DESIGN/PROCESS CHANGE NOTIFICATION

Selected MOSFET products assembled in our Power 56 dual asymmetric clip package. Current singulation method is saw-singulation, lead frame is etched with a pre-molded clip bonding method. For the package dimensional out line please refer to the drawing below.

An alternate singulation method will be a punch-singulation with a stamped lead frame and flat metal clip bonding method for the source. Low Side FET (Q2) gate will be wire Bonded vs Clip bonded. Refer to the dimensional outline drawing below.

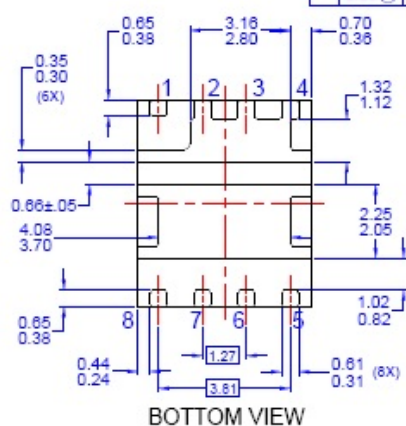
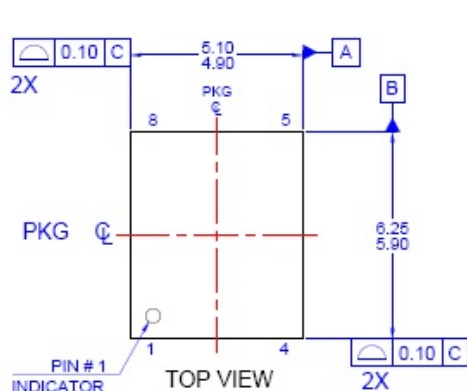
Description of Change (From) :

OPTION - B (PUNCHED TYPE)

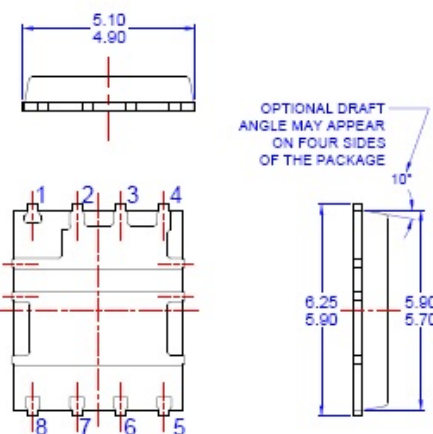
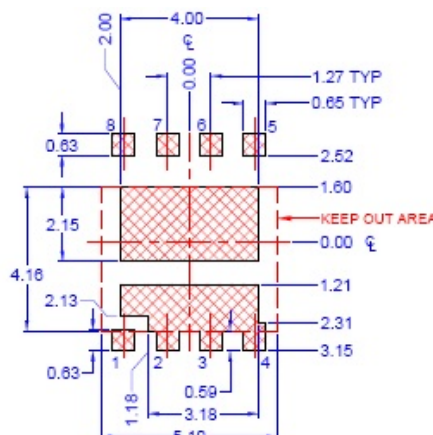
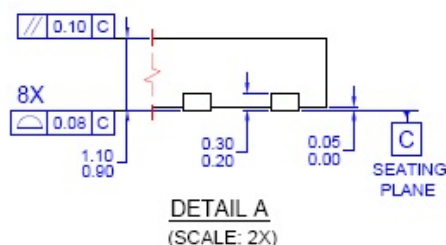
Description of Change (To) :
